## HISTORIC AND DESIGN REVIEW COMMISSION

February 05, 2020

**HDRC CASE NO:** 2020-031  
**ADDRESS:** 533 E CARSON  
**LEGAL DESCRIPTION:** NCB 993 BLK 3 LOT S 96.91 FT 7 (ARB 7C)  
**ZONING:** MF-33, H  
**CITY COUNCIL DIST.:** 2  
**DISTRICT:** Government Hill Historic District  
**APPLICANT:** Mary Jo Vargas  
**OWNER:** Mary Jo Vargas  
**TYPE OF WORK:** Siding and window replacement  
**APPLICATION RECEIVED:** January 17, 2020  
**60-DAY REVIEW:** March 16, 2020  
**CASE MANAGER:** Huy Pham

### REQUEST:

**Proposed:**

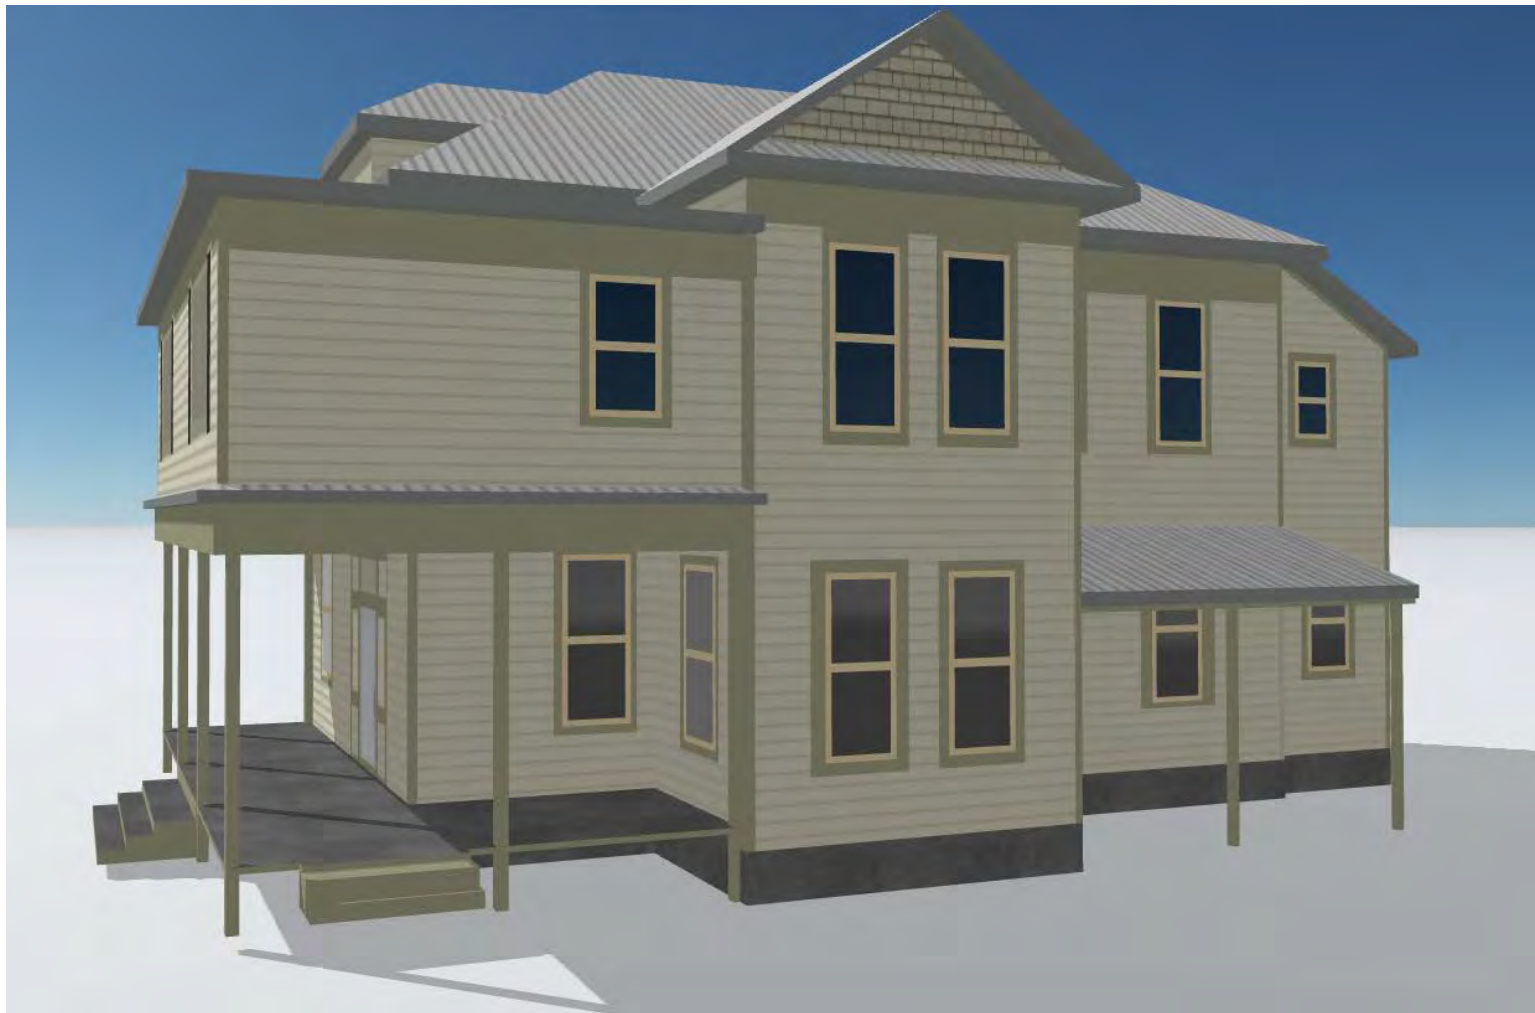
- c. **SIDING REPLACEMENT** – The applicant has proposed to remove all siding (7% original siding, 10% waterfall siding; 13% 105 siding and 70% aluminum siding), insulate and seal the wall cavities, and install all new colonial style smooth composition lap siding (Hardie). The estimated surface of the siding on the structure is approximately 3,710 square feet. Staff finds that wholesale replacement of all siding with new composition siding is inconsistent with the Guidelines for Exterior Maintenance and Alterations 2.A.i through iii. Staff finds that installing wood siding that matches the historic profile is the most appropriate treatment for the restoration of the structure. If the exact historic profile cannot be obtained or custom milled, a comparable wood profile such as 105 or 117 may be considered, whereas aluminum or composite materials should be avoided on historic wall planes.

- e. **WINDOW REMOVAL** – The applicant has proposed to remove the side windows on the second-floor balcony enclosure. Per the Guidelines for Exterior Maintenance and Alterations 7.B.ii., alterations to side and rear porches should result in a space that functions, and is visually interpreted as, a porch. Staff finds that removal of the window openings would result in a space that is not visually interpreted as a porch but instead a non-conforming front porch enclosure that lacks fenestration. Staff finds that the wood window openings should remain in place and that the applicant may consider installing an interior furr wall to accommodate the floor plan.

1. Staff does not recommend approval of wholesale siding replacement based on finding c. The applicant may work with staff to replace aluminum siding with matching wood siding. Composition siding should be avoided on historic wall planes unless otherwise approved by the commission.

3. Staff does not recommend approval of window removal on the front balcony enclosure based on finding e. The applicant may consider installing an interior furr wall to accommodate the floor plan.
